Docket: NRC-2018-0052
Holtec International HI-STORE Consolidated Interim Storage Facility Project

Document: NRC-2018-0052-DRAFT-0263
Comment on FR Doc # 2018-10418

RE: **Docket NRC-2018-0052, Holtec HI-STORE Consolidated Interim Storage Facility Project**

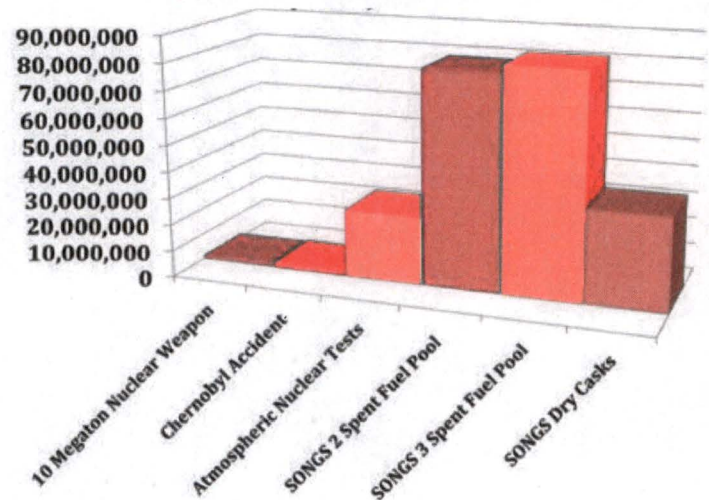
Holtec UMAX lids with large air vents. Round top has outlet air vent. Lower rectangular part of lid has inlet air vents near all corners. Radiation reading at San Onofre were 324 CPM (counts per minute) with no leaks in canister. Carbon-14 is one type of radioactivity released through the air vent. NRC only requires radiation monitoring once a quarter. No monitoring system exists to alert before leaks in canisters.

Canisters are vulnerable to short-term cracks and leaks from various environmental causes, such as highly corrosive chlorides found in marine environments, and in Potash (Potassium Chloride) found in New Mexico. **New Mexico provides 75% of the nation's supply of Potash.** The above-ground large air vents in the Holtec UMAX system will allow corrosive particles, rain and flood waters to enter the Holtec holes and corrode the exterior of the thin-wall canisters. The canisters are never cleaned and there are **no drains** in the Holtec UMAX holes that hold each canister.

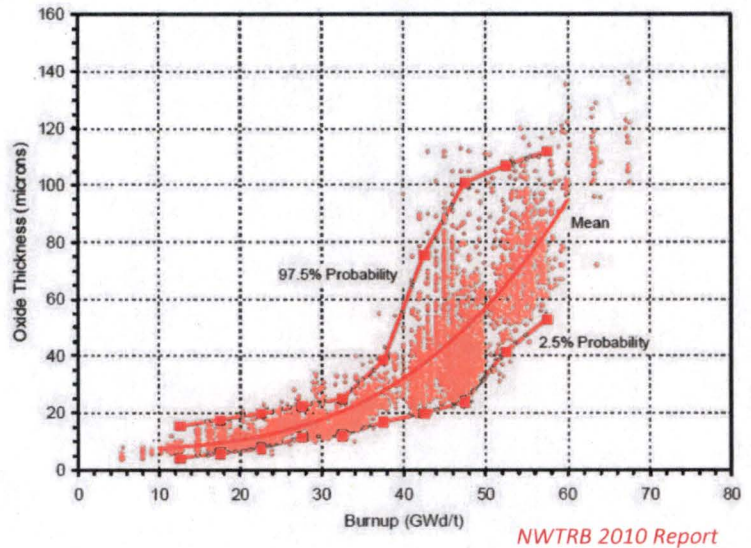
Tom Palmisano stated he is aware of only one dry storage container that has been returned to spent fuel pools. This was in 2010 with a Peach Bottom TN-68 thick-wall cask design. Unlike hot thin-wall welded canister systems, this thick-wall cask has a bolted lid, designed to be opened without destroying the container. It had much cooler fuel than what is typical in the U.S. for thin-wall canister storage. It did not contain high burnup fuel and had cooled for decades. The cask contained low burnup fuel (under 30 GWd/MTU). It had then cooled for a decade in dry storage.

The Peach Bottom cask, rather than being stored in a building for additional environmental and security protect, as is done in other countries, had a bolted on carbon steel protective cover. Moisture collected under the cover creating galvanic corrosion, prematurely degrading a seal. Peach Bottom should store their thick casks in buildings. The Peach Bottom cask continuous pressure monitoring system worked, so the system worked as designed for maintenance. With thin-wall canisters, there is no pressure monitoring system. We will only know after canisters leak, explode or go critical. Peach Bottom Atomic Power Station - NRC ISFSI Inspection Report 05000277 1201 00 1 0, July 8, 2011
<https://www.nrc.gov/docs/ML1118/ML111890441.pdf> and NRC Information Notice 2013-07: Premature Degradation of Spent Fuel Storage Cask Structures and Components from Environmental Moisture, April 16, 2013 <https://www.nrc.gov/docs/ML1232/ML12320A697.pdf>

Stress Corrosion Cracking Background Information

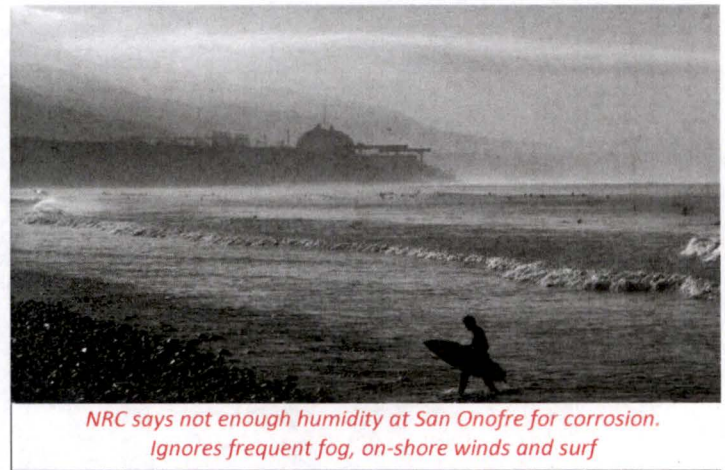
2/3 of the requirements for SCC are present in welded stainless steel canisters

- 304 and 316 Stainless steels are susceptible to chloride stress corrosion cracking (SCC)
 - Sensitization from welding increases susceptibility
 - Crevice and pitting corrosion can be precursors to SCC
 - SCC possible with low surface chloride concentrations
- Welded stainless steel canisters have sufficient through wall tensile residual stresses for SCC
- Atmospheric SCC of welded stainless steels has been observed
 - Component failures in 11-33 years
 - Estimated crack growth rates of 0.11 to 0.91 mm/yr

The NRC needs to stop being an enabler of inferior technology. NRC claims, such as Darrell Dunn's claim, that there is not enough humidity at San Onofre for corrosion is ludicrous. He does this by ignoring conditions of frequent fog, on-shore winds and surf.
